Safety Analysis Report for the West Valley Melter Package

SARWVMP-01

Responses to the U.S. Nuclear Regulatory
Commission Requests for Additional Information
on the Safety Analysis Report
for the West Valley Melter Package
(SARWVMP-01)

USNRC Docket Number 71-9797

Figure 2-5. Configurations for Tie-Down Assessment

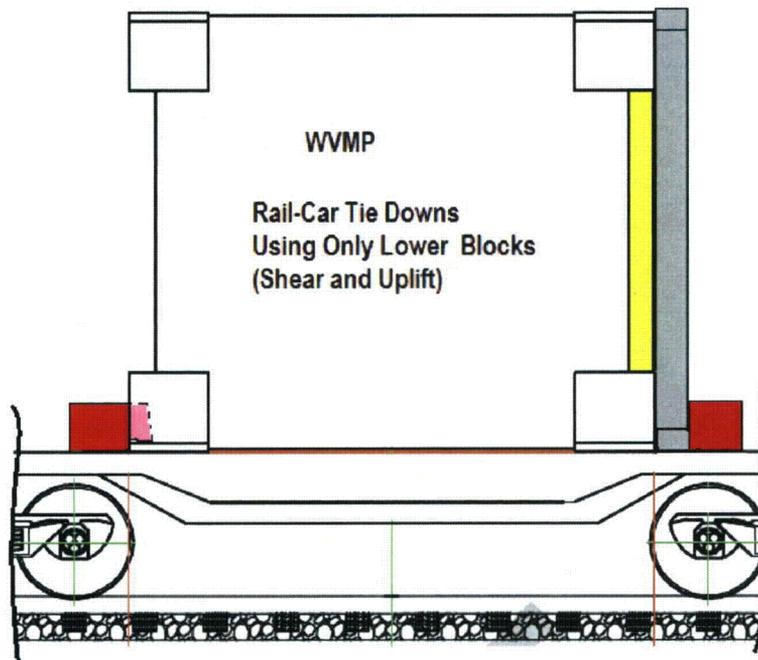
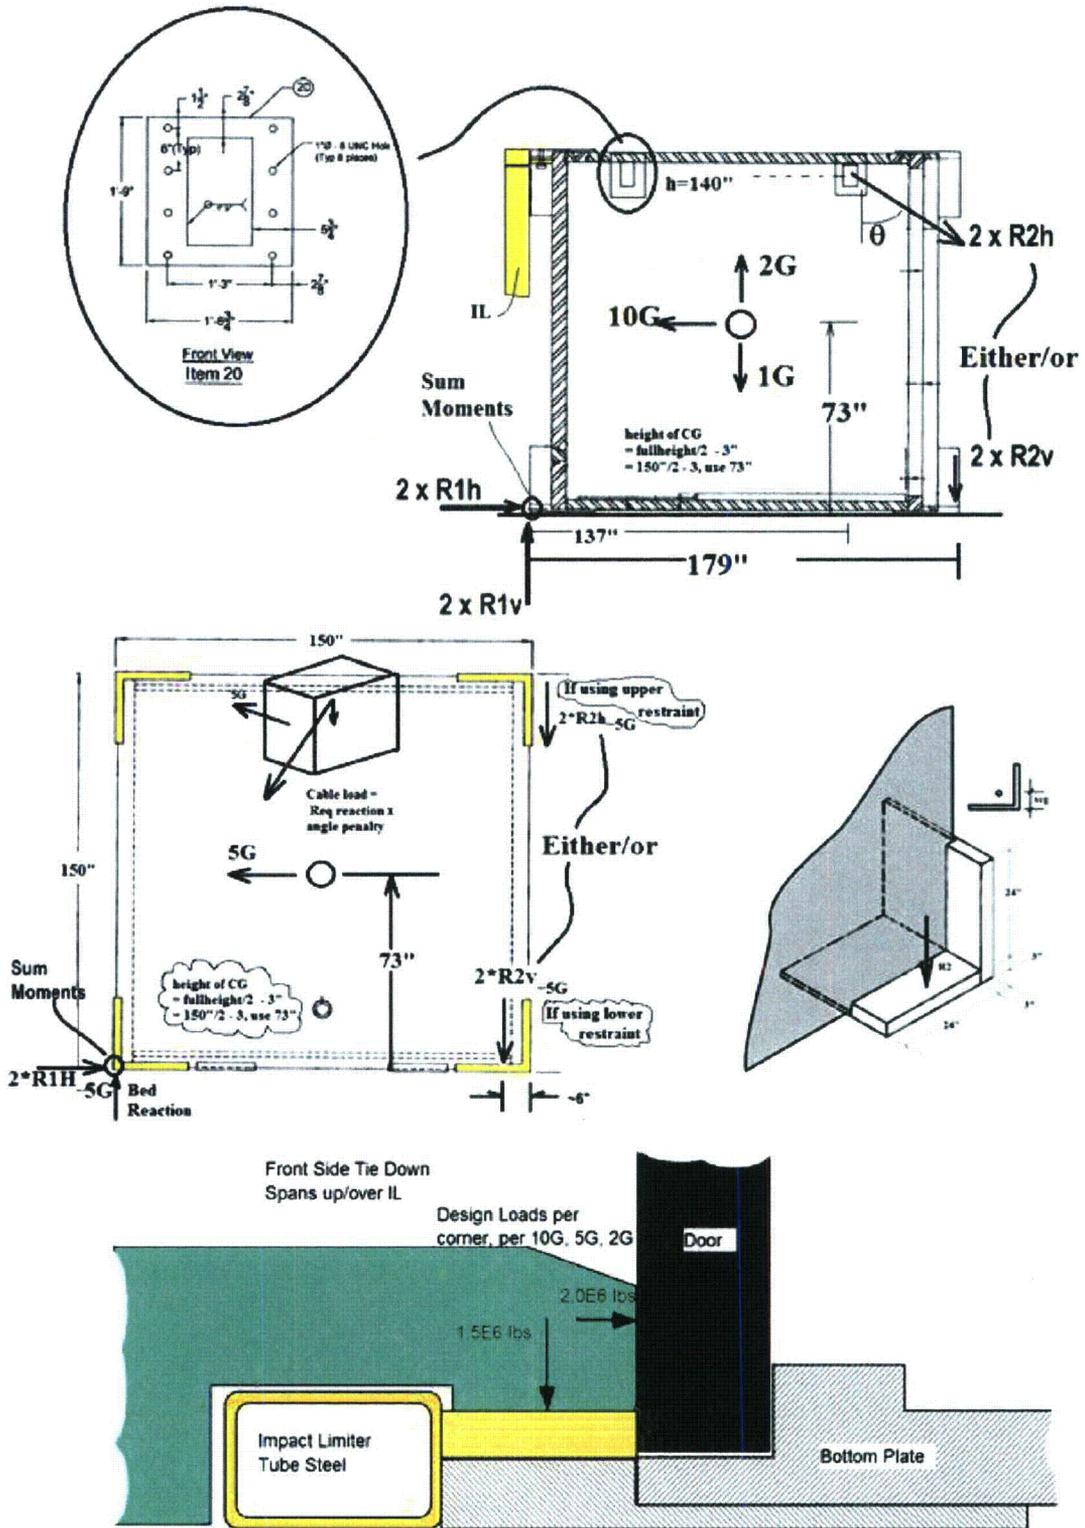
RAI: Provide a detailed description and analysis for the tie-down configuration that will be used to secure the package to a trailer and/or rail car, including the corresponding free body diagrams that indicate all points of force application and all points of restraint.

DOE response: The WVMP will be tied down for two modes of transportation, one configuration for heavy haul truck and another for rail transport. Information has been added to Section 2.5.2 to clarify this point.

Changes to the SAR: The tie down section was revised to show tie-down methods used in road transport and in rail transport. A new figure was added to depict both arrangements. The old figure 2-5 (now 2-6) was revised to show shear and compression restraint terms to match the calculations.

Figure 3-10. Variation of Average LDCC and WVMP Air Pocket Temperatures during the HAC Fire Scenario, With Natural Convection in the WVMP Air Pocket

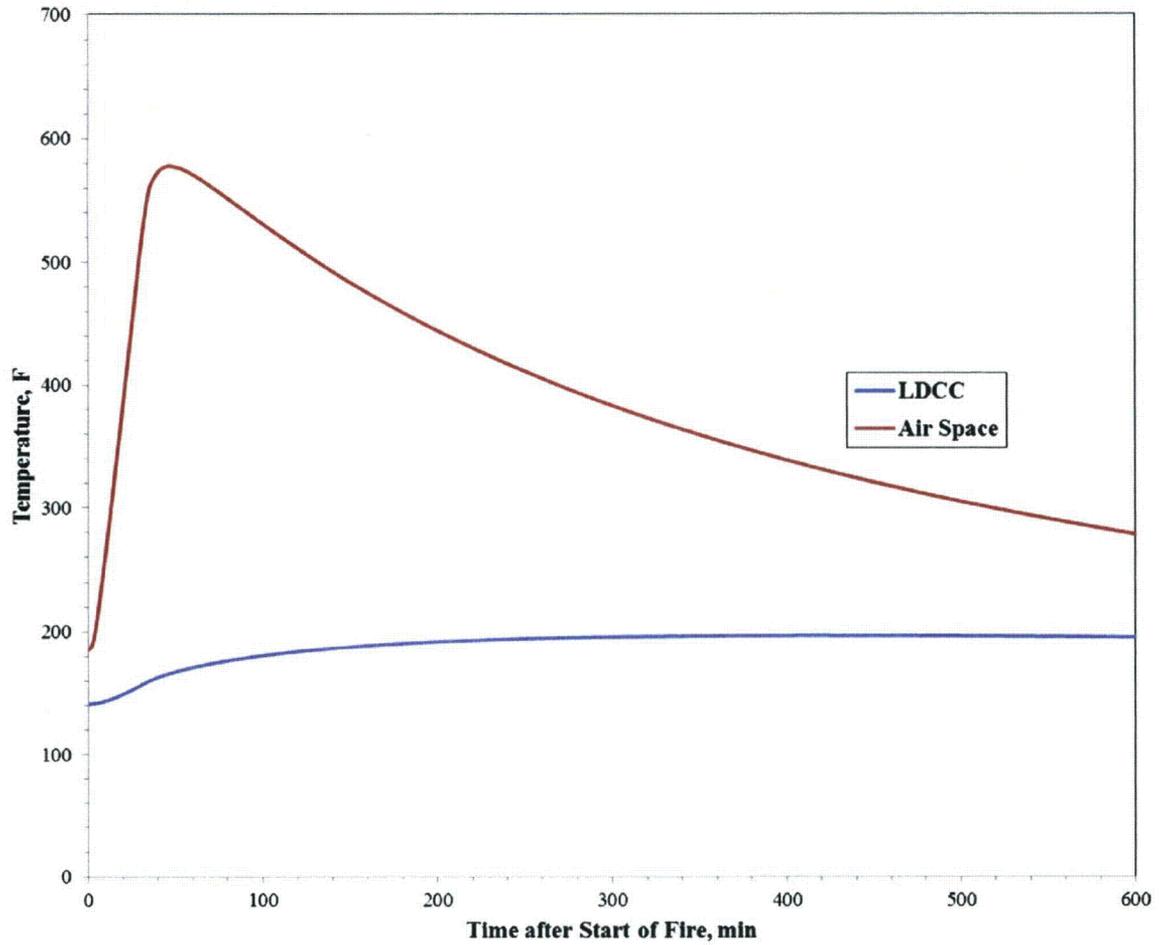
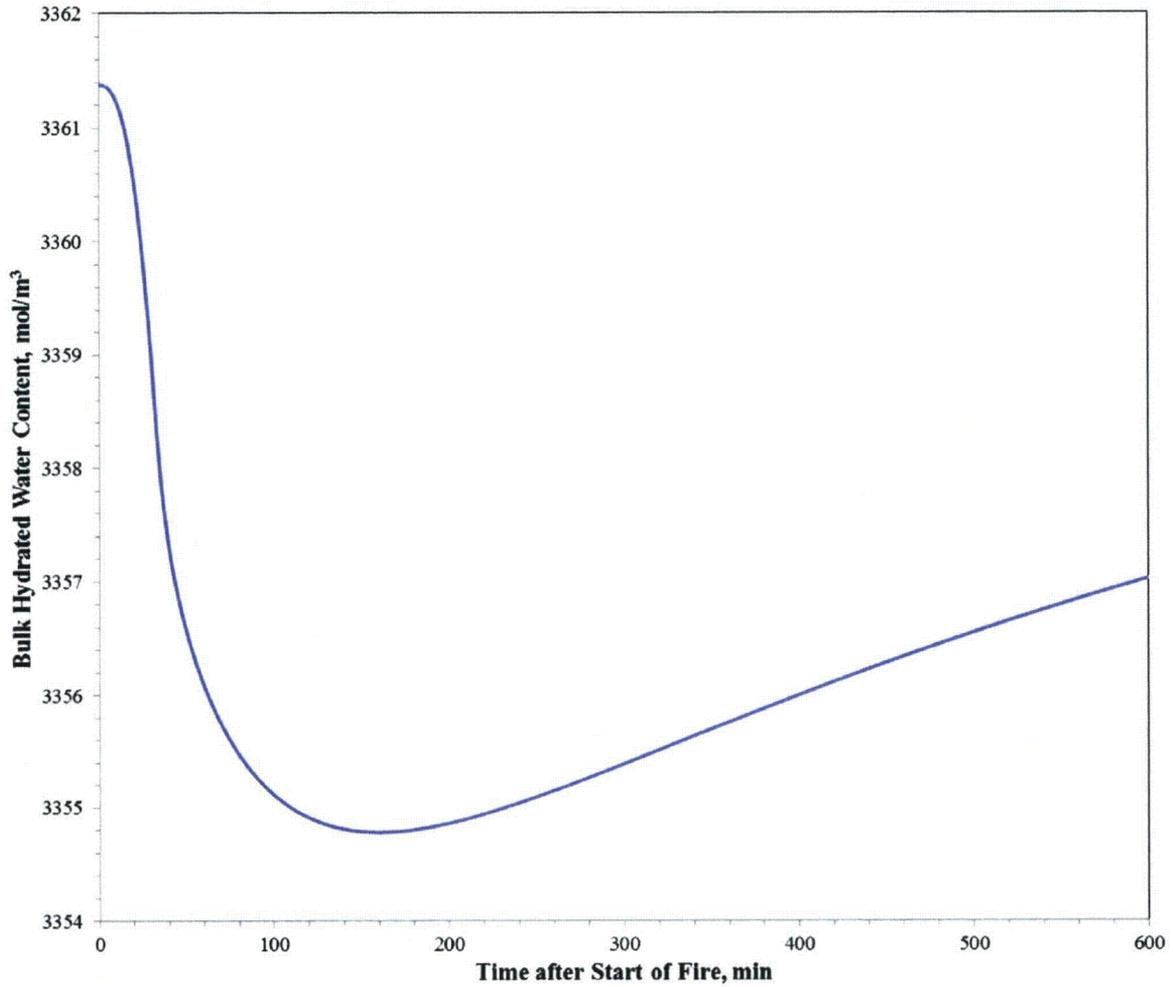
RAI: Provide calculation results (tables, figures, etc.) to demonstrate that, during an HAC fire, the omission of natural convection heat transfer in the package air pocket is conservative.

However, the applicant did not provide results for the case when natural convection is included. The applicant needs to provide results for both cases in tabulated and graphic form for the staff to determine the adequacy of the analysis assumptions.

DOE response: The additional results, including natural convection, were reported in the revised calculation note supporting Rev 0A of the SAR in Appendix 3.5.4 but were omitted from Chapter 3 since they were not the bounding pressure. The results from the calculation in Appendix 3.5.4 have been incorporated into the text of Chapter 3.
